STATE OF WASHINGTON
DEPARTMENT OF ECOLOGY

Re: Comments to Draft Off-Property Survey and Groundwater Monitoring Work Plan

- **Site Name:** Texaco 211577 Monterey
- **Site Address:** 631 Queen Anne Avenue N, Seattle, WA 98109
- **Facility Site No.:** 77774779
- **Cleanup site ID:** 6663

FORMER TEXACO SERVICE STATION CHEVRON SITE No. 211577 631 QUEEN ANNE AVENUE NORTH SEATTLE, WASHINGTON	FIGURE 3-10 GROUNDWATER ELEVATION CONTOUR MAP NOVEMBER 2005
	FILE NAME: 211577_RI Basemap figures.dwg	DATE: 08/10/2007

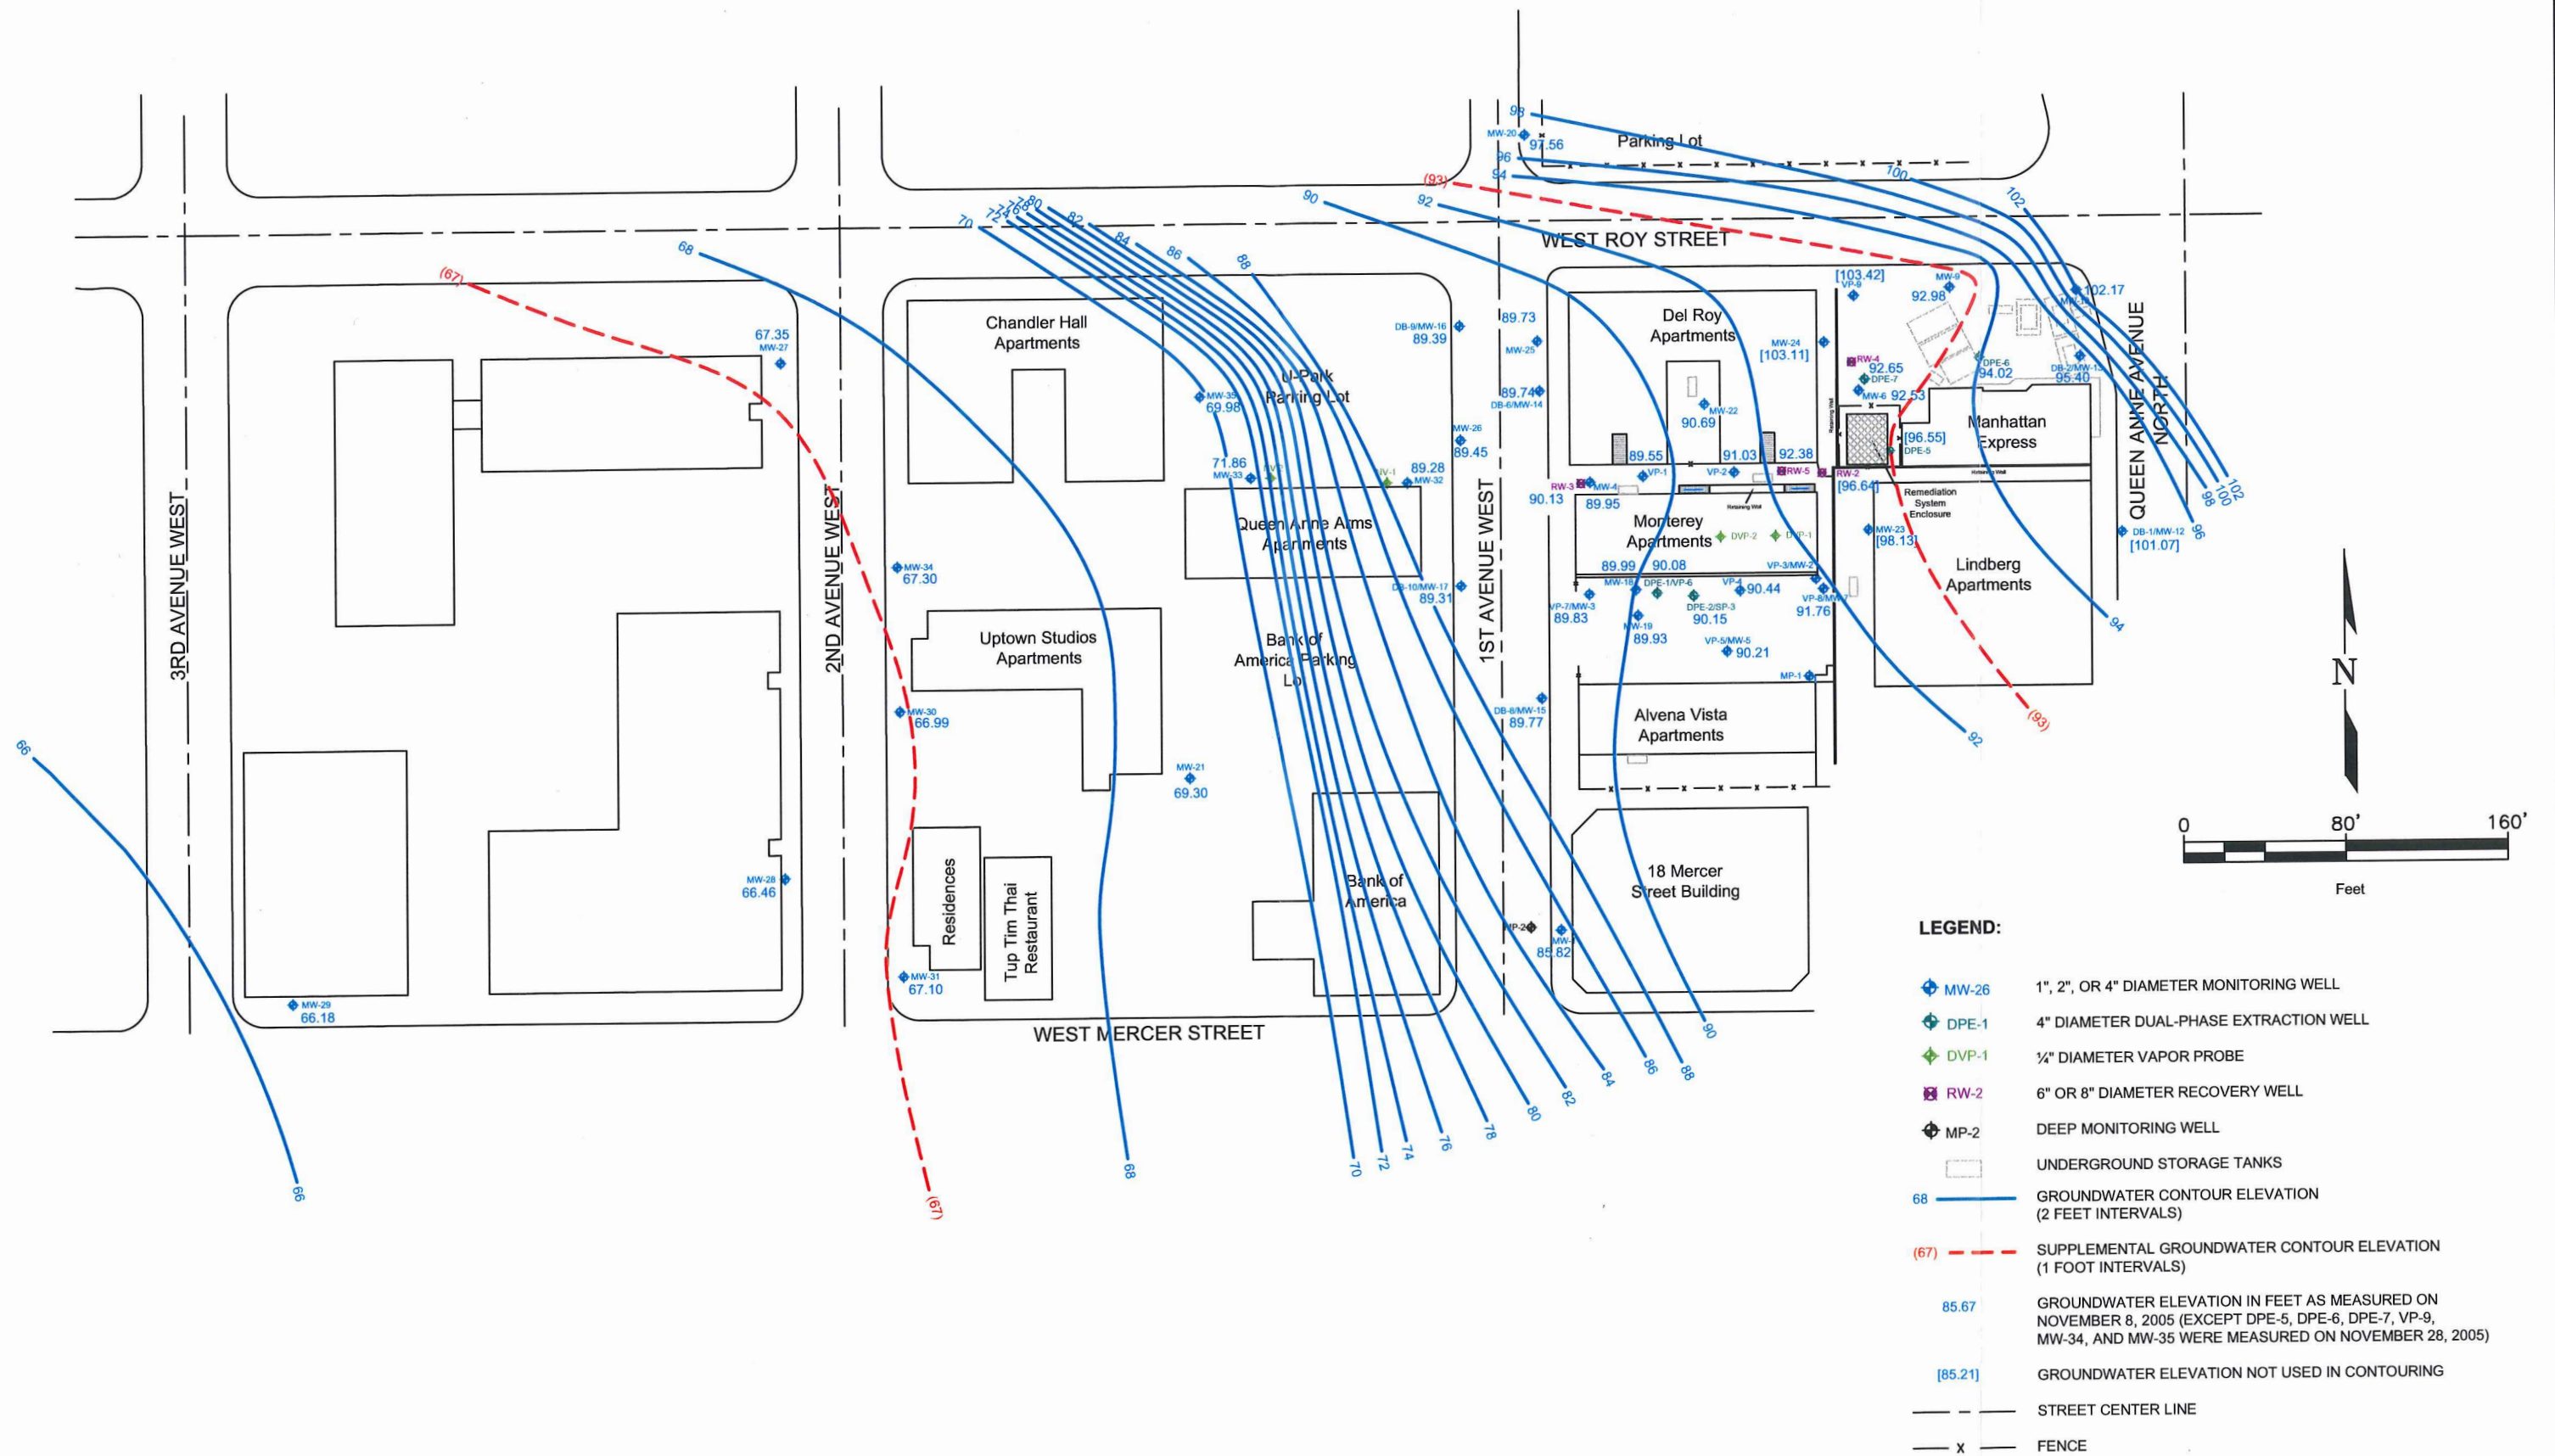
2. Ecology has reviewed CEMC's *Final Remedial Investigation and Site Summary Report (RI Report)*, dated August 20, 2007. Monitoring well MW-29, located on West Mercer Street ROW, is not included on Figure 2 of the current *Work Plan*. According to the 2007 *RI Report*, CEMC took custody of monitoring wells MW-27 through MW-29, and added the three monitoring wells in the ground water monitoring program at that time. The three monitoring wells were originally installed in 1994 by Law Crandall for the Queen Anne Square Association. A figure from the 2007 *RI Report* showing the monitoring well locations (including well MW-29), is included in **Enclosure A** of this letter.

Please include monitoring well MW-29 in the planned monitoring well survey and sampling network, and revise Figure 2 of the *Work Plan* accordingly.
